Certified Action of the City of Raleigh Planning Commission

Case File / Name: SP-48-09 / Contemporary Art Museum

SP-48-09 / Contemporary Art Museum – Preliminary Site Plan

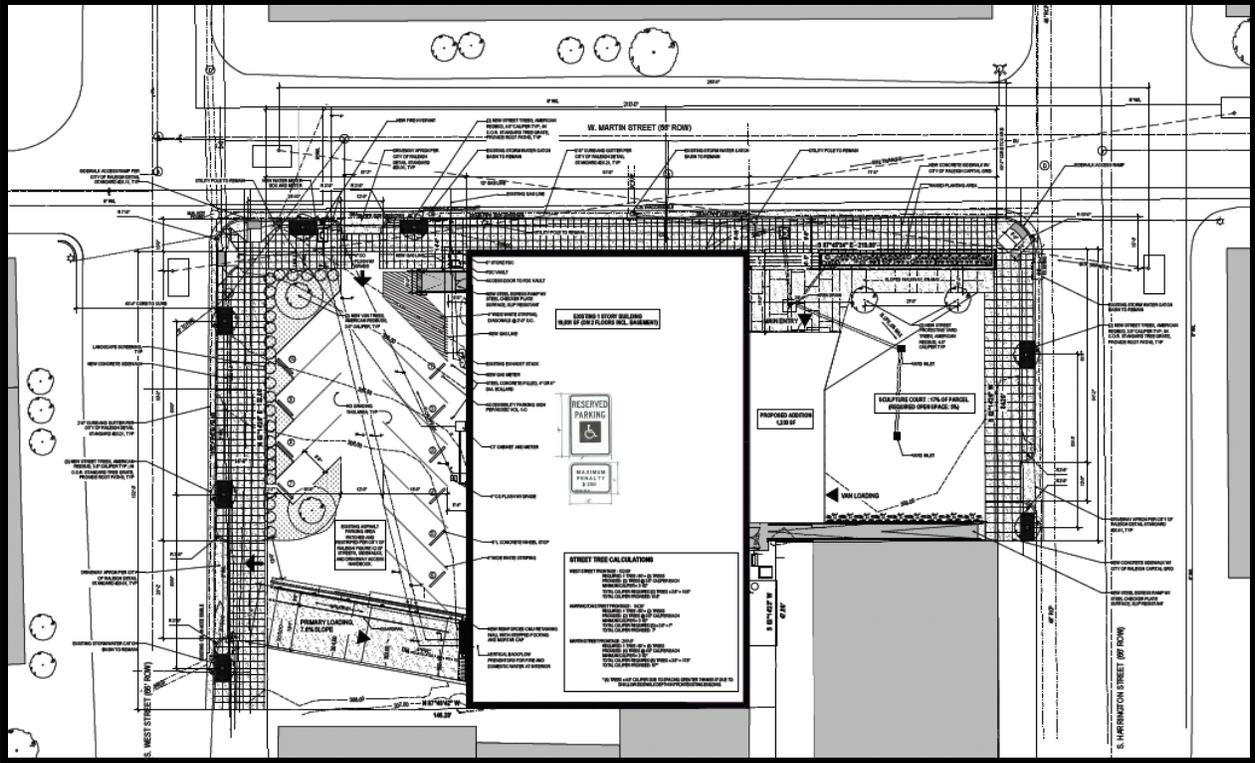
Key Issues: As presented, staff finds that this plan does not conform to Code standards and adopted land use policies as they relate to open space and the provision of 14 foot wide sidewalks intended to promote and support intensification of the Downtown and the planned Downtown Multi-Modal Center located just a portion of a block to the west.

While this proposal includes provision of open space which exceeds the overall size requirements, the plan does not meet the location requirements for where open space is to be provided- specifically in regard to providing 14' width sidewalks where practical along West Martin Street. The proposal shows an approximately 10' width sidewalk along 150' of street frontage- 80' of street frontage adjacent the existing building and another 70' of street frontage where new construction is proposed. Staff opposes the reduction in sidewalk width in the area beyond the existing building and has included a condition of approval requiring a new site plan be provided with a 14' width sidewalk in that location. (continued on next page)

- (1) That a revised preliminary plan be submitted that provides 14' width sidewalks on all portions of West Martin Street except for the frontage adjacent to the existing building. In accordance with Code Section 10-2051(d)(5), the applicants shall revise the proposed plan to include a 14' wide sidewalk along the section of Martin Street that lies east of the existing building all the way to Harrington Street as there are no pre-existing conditions which preclude its installation;

- (2) That in accordance with 10-2082.4 (Landscaping Alternate Methods of Compliance), the Planning Commission approves an alternate to the spacing requirements of Section 10-2082.5 for the portion of West Martin Street north of the existing building where the installation of a street tree within the 8'10" sidewalk would impede pedestrian movement. The spacing between the street tree located east of the building and the street tree west of the building is approved to be 130' in this location. All other street trees east and west of the building shall be in tree grates in the right of way and consistent with the Urban Form for downtown. Tree size is to be a minimum of 4.5" caliper. City Code minimum tree size is two inches in caliper;

PEDESTRIAN: Proposed sidewalk locations conform to City regulations with the exception of portions of Martin Street. The Downtown Overlay District requires 14' wide sidewalks to be located along all three streets bordering the subject property. In accordance with Code Section 10-2051(d)(5), the applicants are seeking approval of an alternate sidewalk width along the majority of Martin Street. As the proposal includes the rehabilitation of an existing building, 14' sidewalks are not feasible along the portion of the Martin Street sidewalk that is between the curb and the existing building. Staff supports that part of the applicant's alternate request for that portion of the sidewalk between the existing building and the curb to remain at 8'10". However, the 70' long sidewalk section east of the existing building along Martin Street is only proposed to be 10' in width. The applicants are proposing to install a raised planter in this location in front of a proposed sculpture court. There are no existing conditions that preclude the construction of 14' wide sidewalks in this location and the courtyard could be redesigned to accommodate the additional 4' of sidewalk along Martin Street. Given the pedestrian-intensive nature of the planned Multi-Modal Transportation Center located roughly 1/2 a block away from the subject property. Staff cannot support an alternate to the 14' sidewalks in this location.
